RUSSELL PRESERVE

Z-12 (2015)

FST Rezoning 18 UNITS SHOWN (8 U/AC = 27.8 max) (28x80 UNIT)

ZONING COMMENTS:

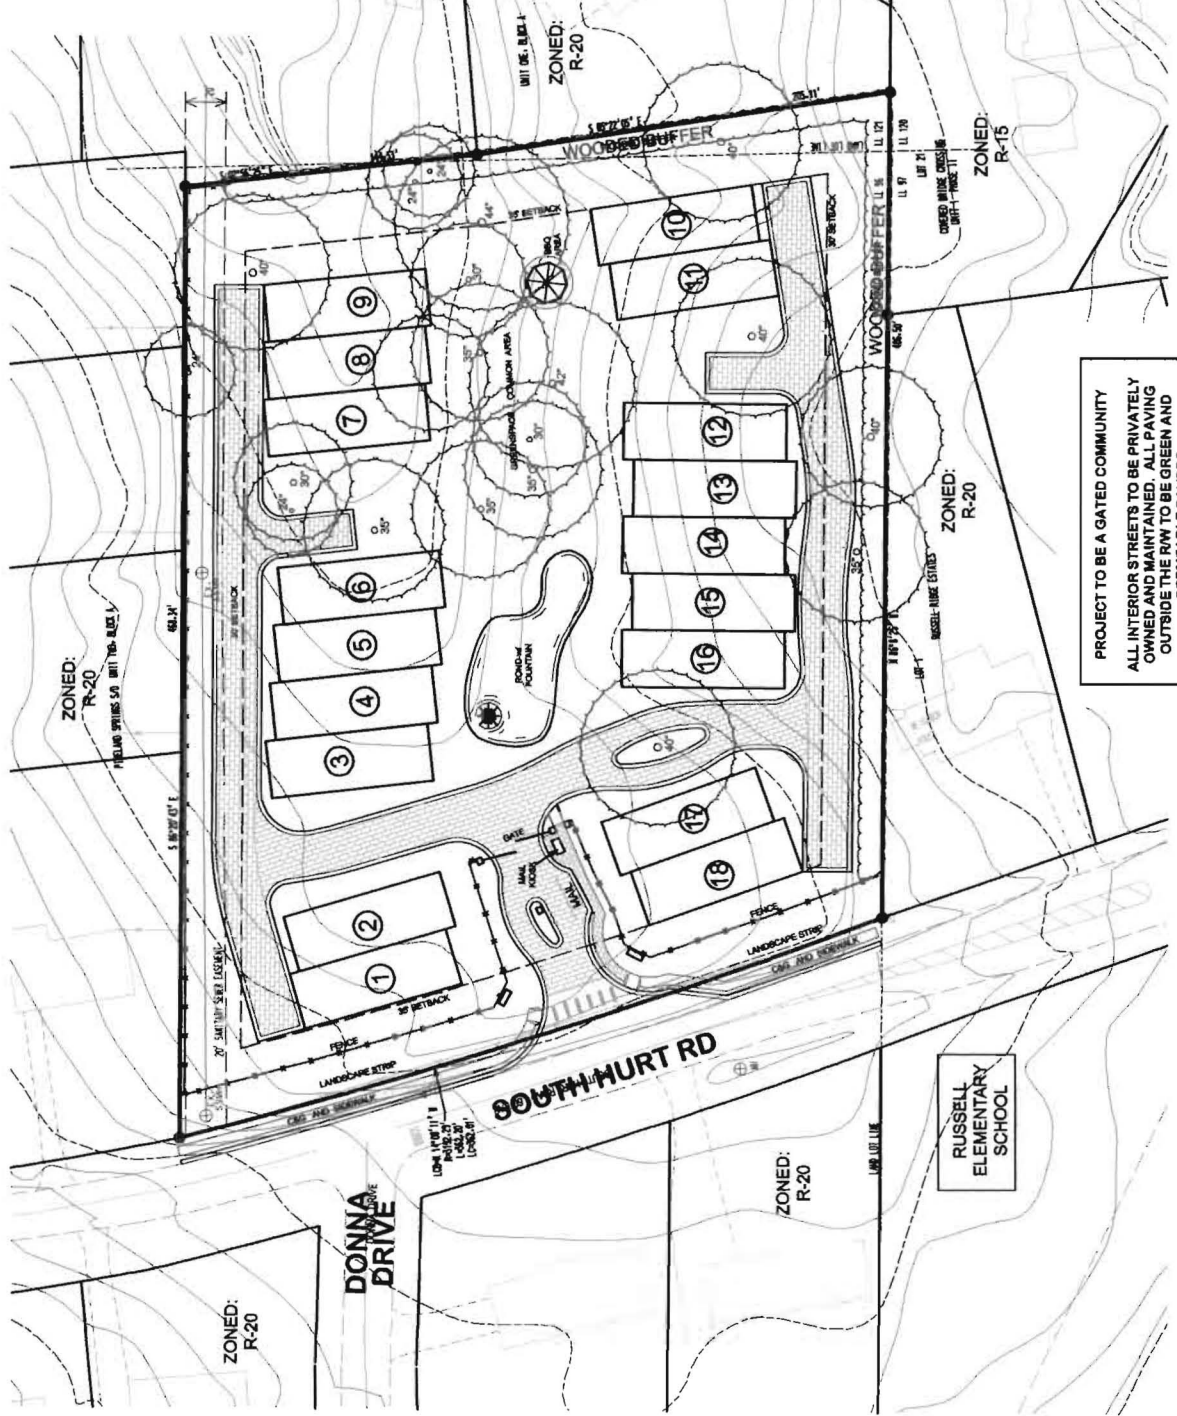
- No Stormwater controls shown _____
- Copy of survey is not current – Additional comments may be forthcoming when current site conditions are exposed.
- No site improvements showing on exhibit.

1. This site is located just east of South Hurt Road. The entire parcel drains to the east into and through the Foxfire Forest Subdivision. There is an existing private culvert located just downstream of the site that may be undersized.

2. There are multiple downstream drainage complaints and capacity issues due to the age of these developments. To mitigate these impacts, the First Flush Water Quality Best Management Practice Requirements must be elevated to the 1.5-inch rainfall event and each larger storm discharge controlled not to exceed the allowable discharge of the next lower, more frequent storm event (ie. 5-year storm event released at 2-year rate; 10-year event at 5-year rate; etc. to 100-year event at 50-year rate).

3. Townhome developments are considered private which will require that all stormwater infrastructure be maintained by the HOA. The current layout will likely require the use of underground detention which will likely result in higher maintenance costs than a typical above-ground facility. A revised plan that utilizes an above-ground system is recommended for such a small development.
